DEVELOPMENT REVIEW BOARD
SUPPLEMENTAL SUBMITTAL

PROJECT NO. 2020-003461 (17EPC-40043)
Application No. SI-2020-00052

SUBMITTAL DESCRIPTION: Revised plans, Approved Fire One, and response to comments

RE: Project #2020-003461/SI-2020-00052 (17EPC-40043), Taylor Ranch Housing
Site Plan-EPC Major Amendment

| | | F1 |

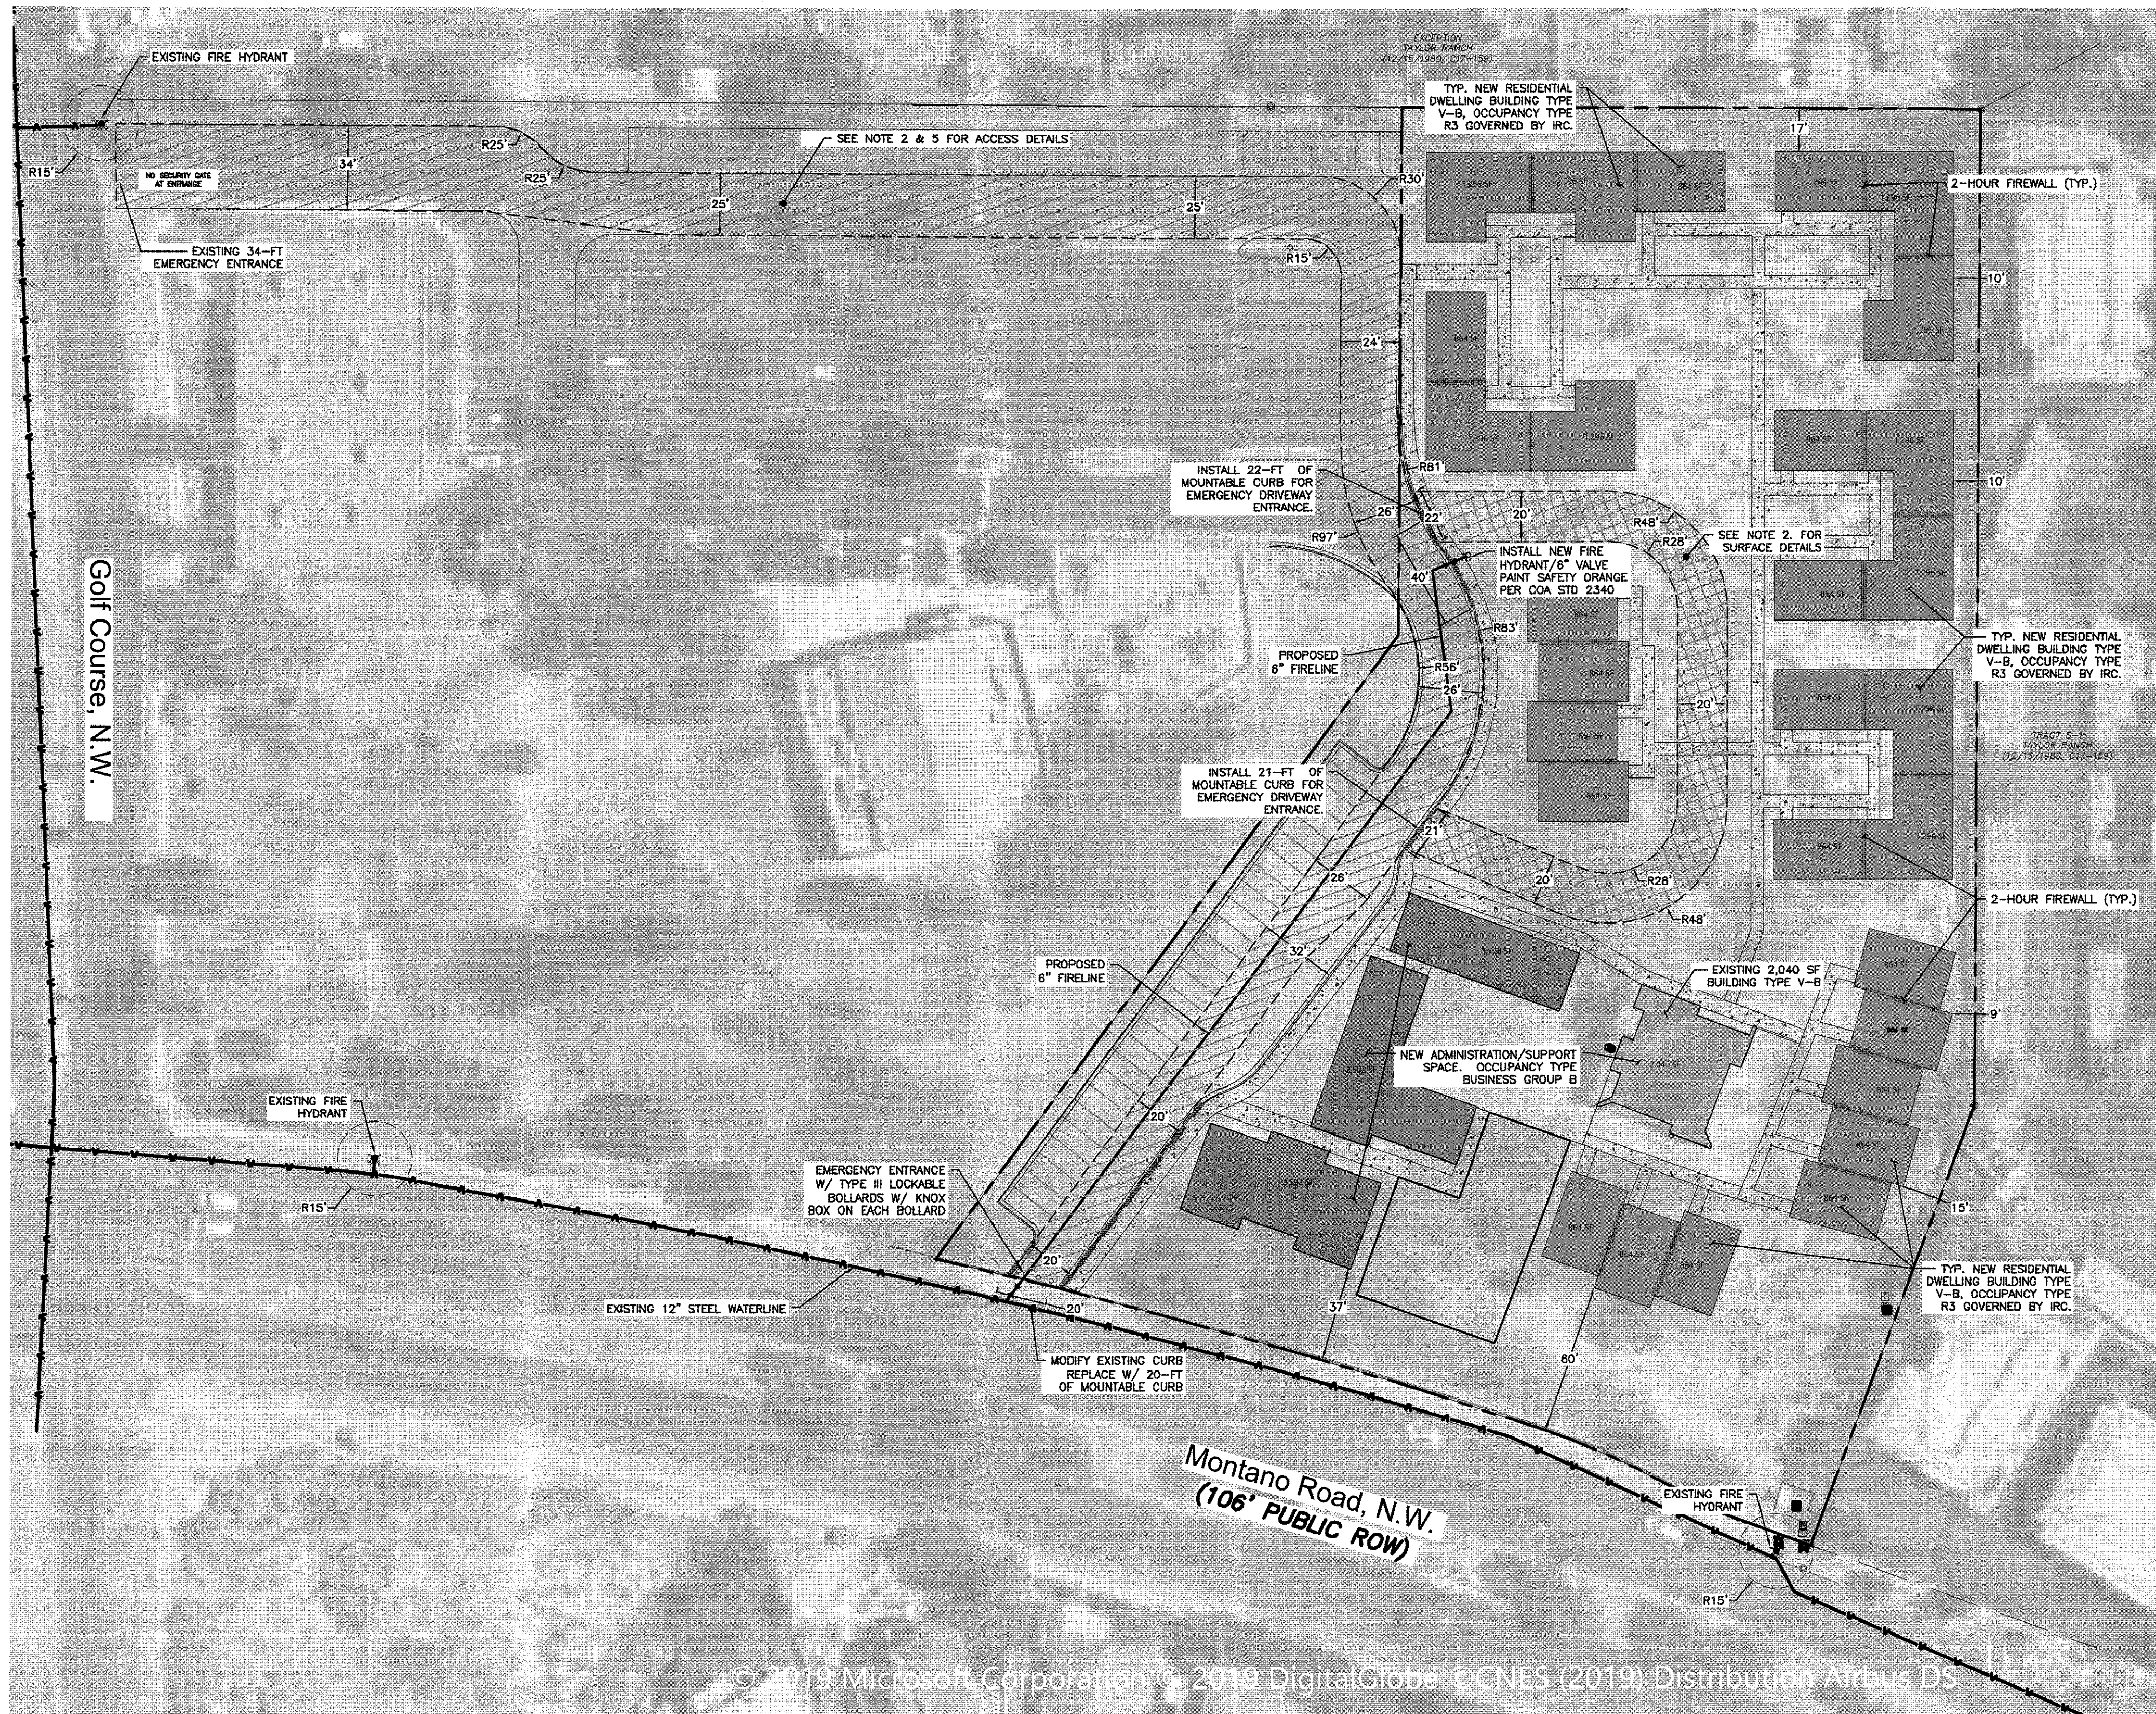
2. Please be sure to include Fire Marshall approval of the site plan.

Response: Fire One plan included with resubmittal.

DRAWN BY
 BF
 DATE
 7/28/2020
 2019080_SPE
 SHEET #
C1
 JOB #
 2019080

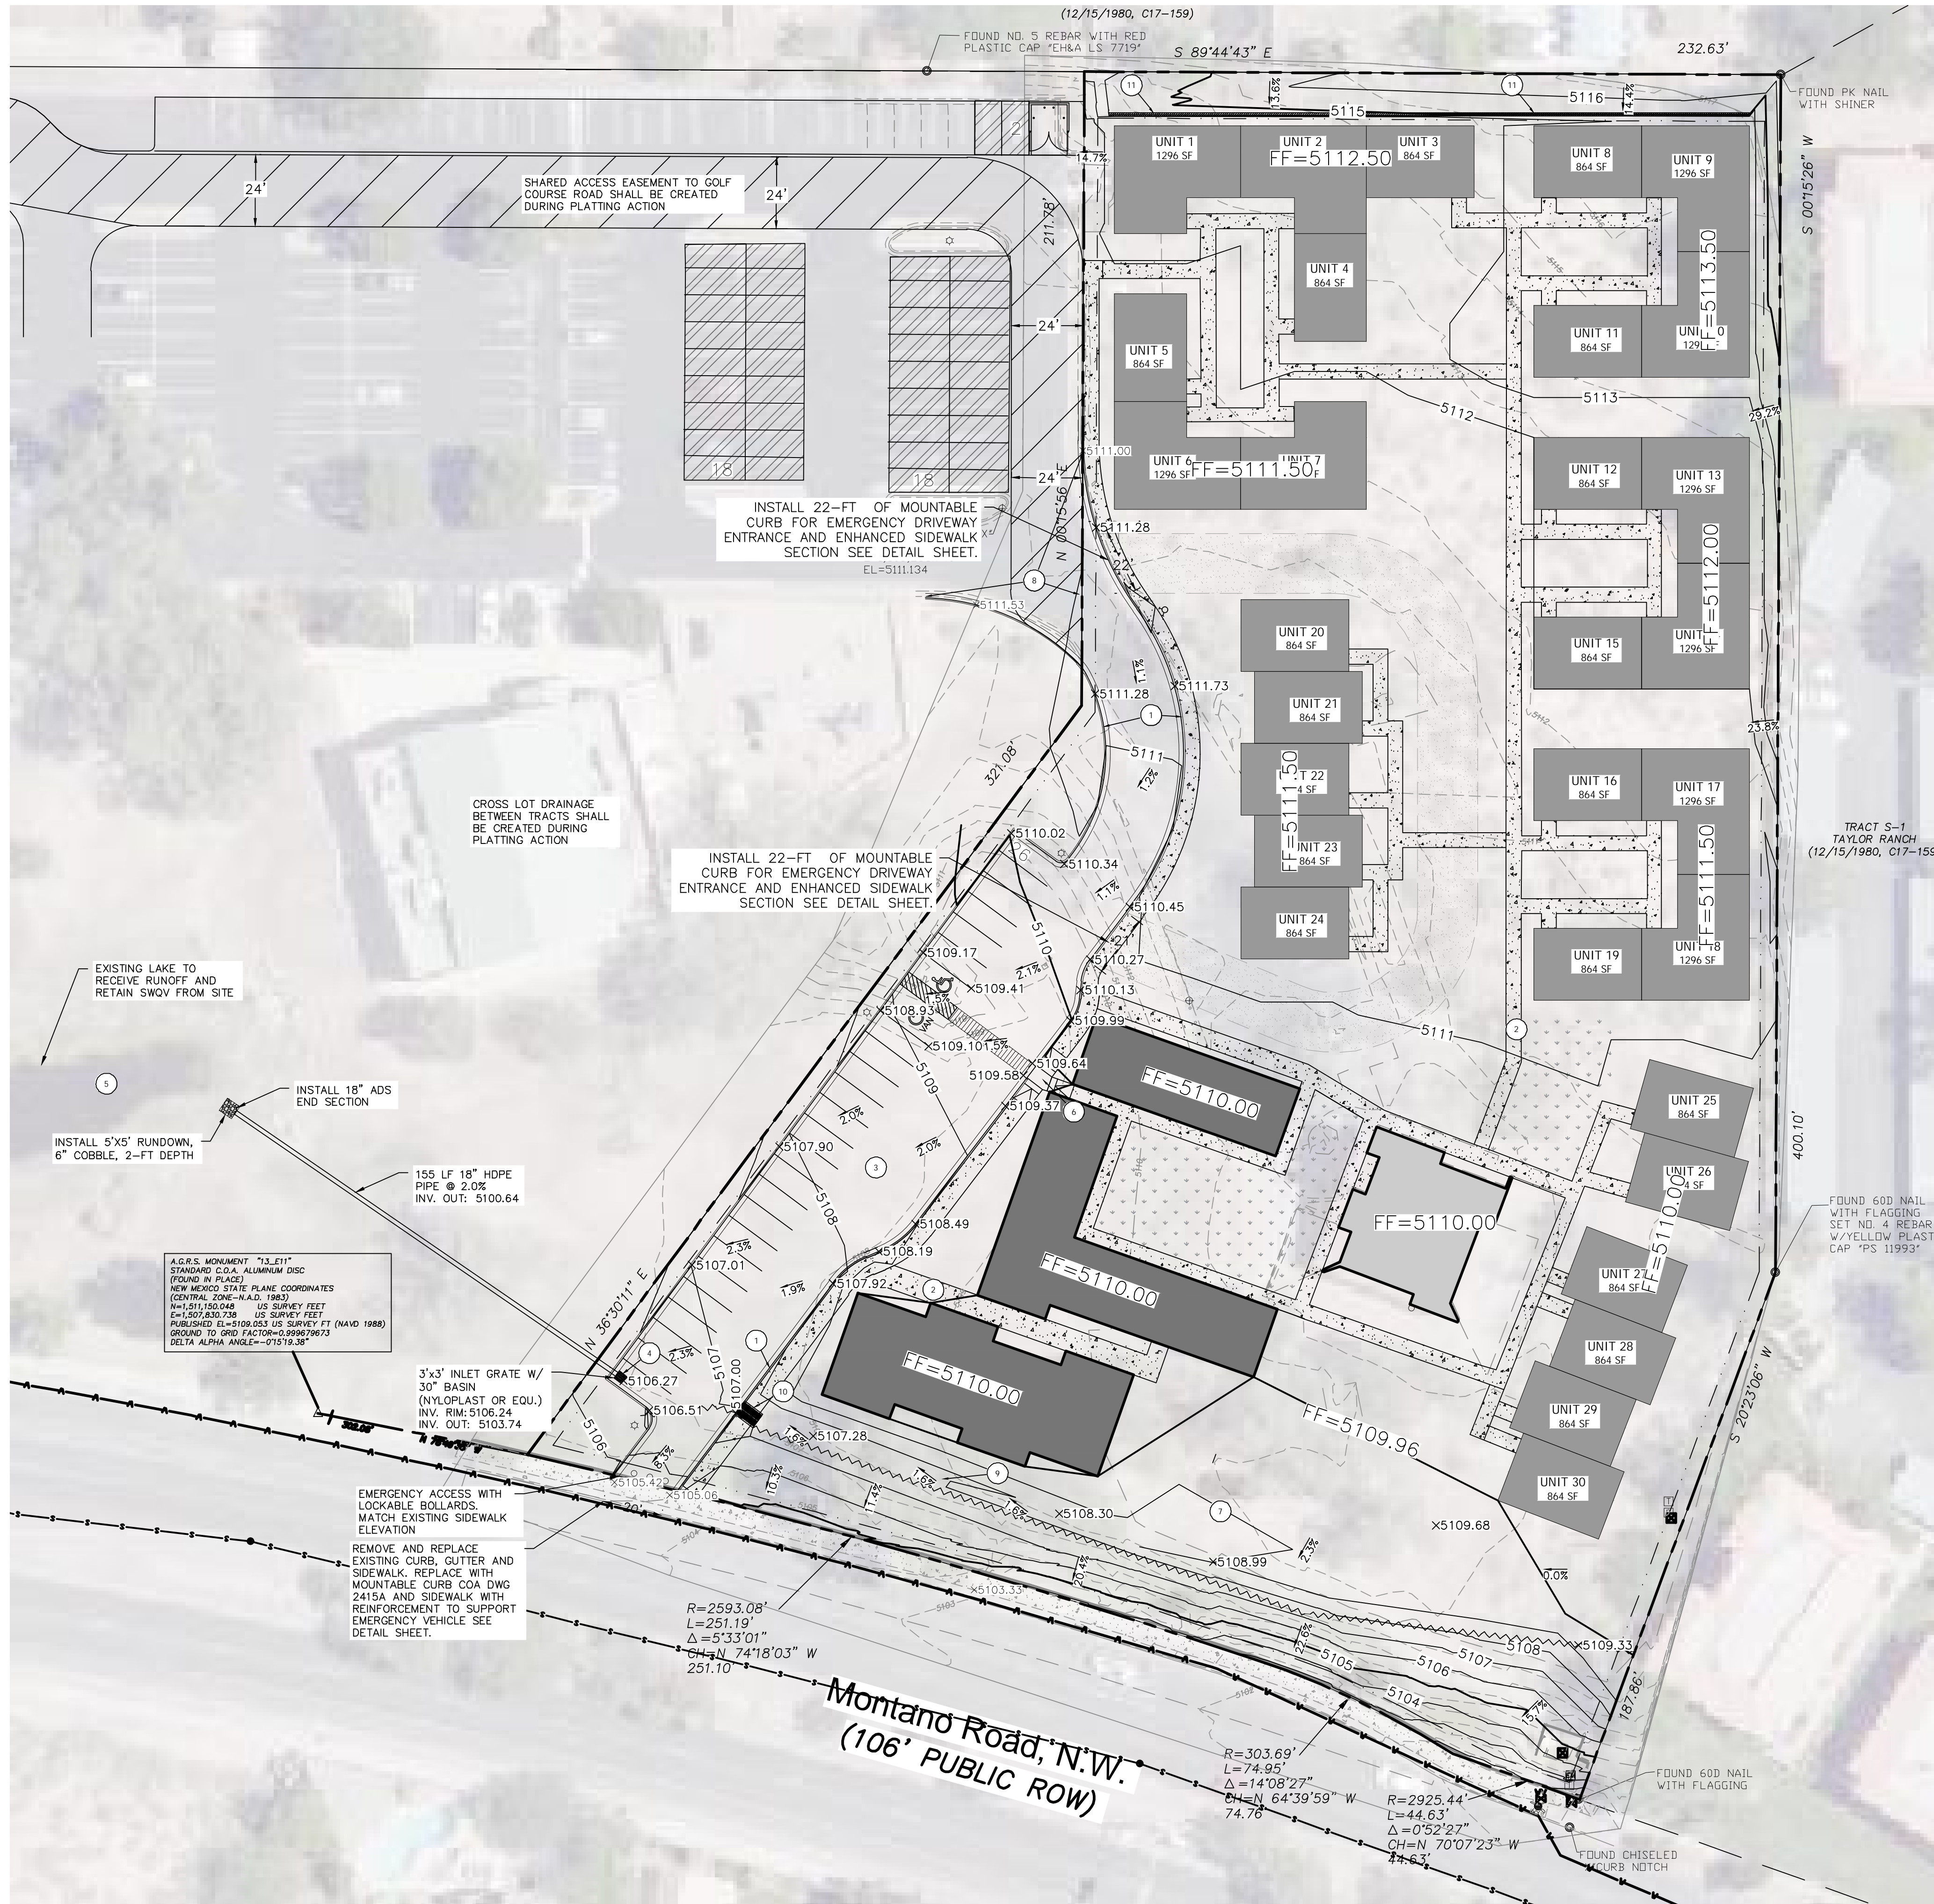
4. For anything that is emergency access, signage shall be provided at the access off of the public right-of-way.

8. Label Tract 27-A-1-A for shared parking. Shared parking can be established on the plat. What is required parking for Tract 27-A-1-A so that it can be established that all parking requirements are sufficient.

1. Condition 3B- correction: It appears that 16 spaces are provided, though the main site plan says 12 spaces.

Response: An emergency access no parking sign was added to the site plan C-1. The Fire Marshall will inspect the property prior to occupancy and any additional requirements shall be installed as necessary to meet IFC requirements.

Response: Note added to C-1 to label the 19 additional parking spaces covered under the shared parking.

Response: Site Plan updated and details 16 spaces provided (C1).

DUMPSTER ENCLOSURE DETAIL

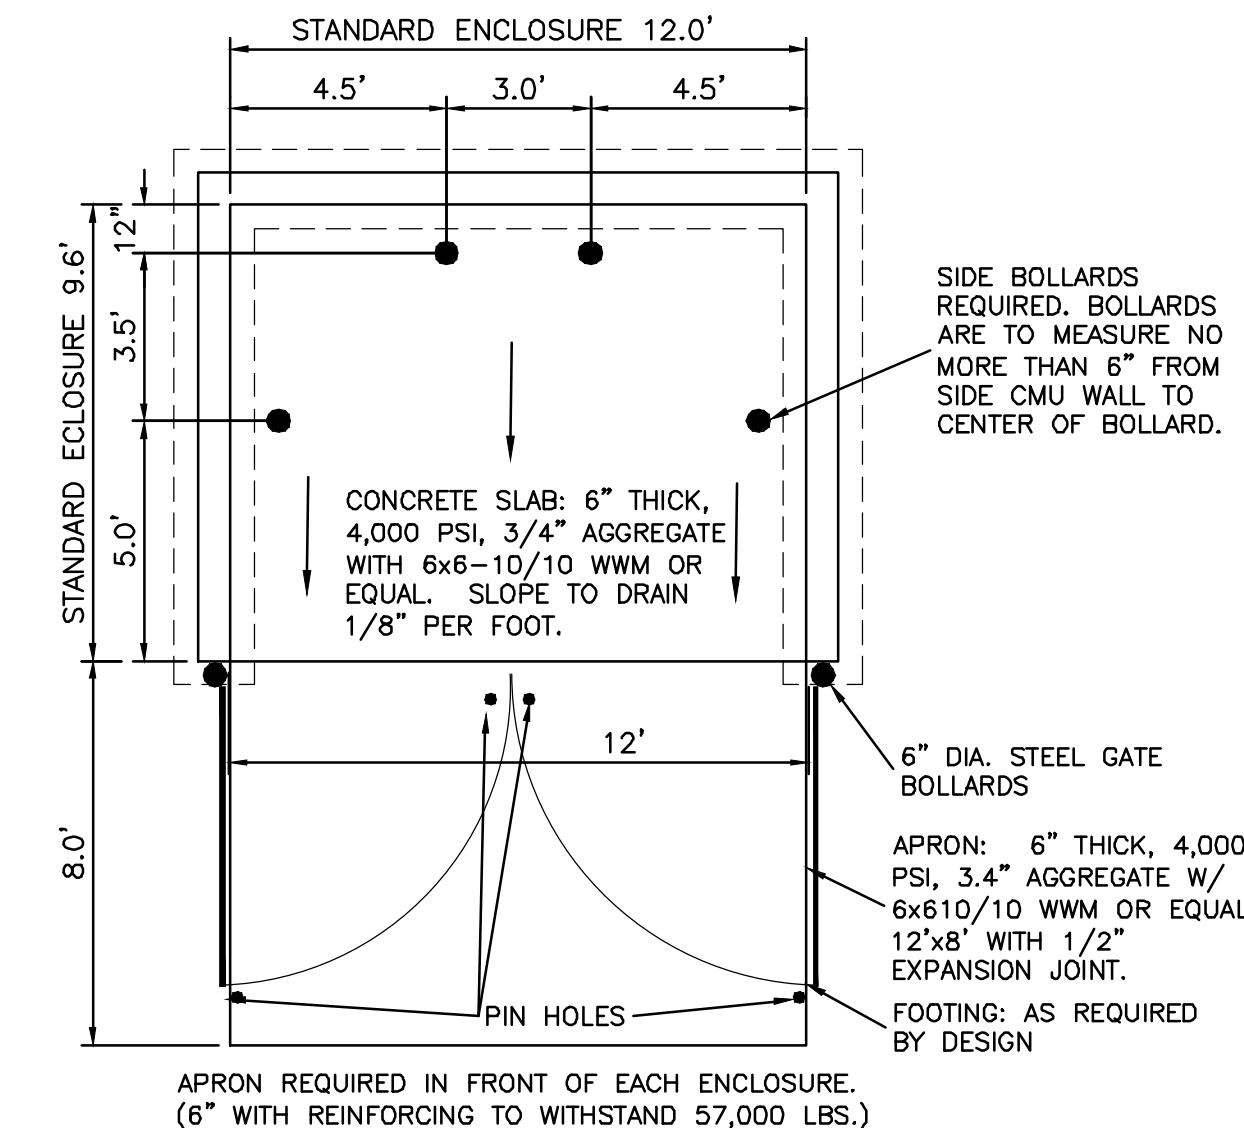
9. Condition 8C- unmet in part: The refuse enclosure detail does not specify color(s).

Response: Color reference added.
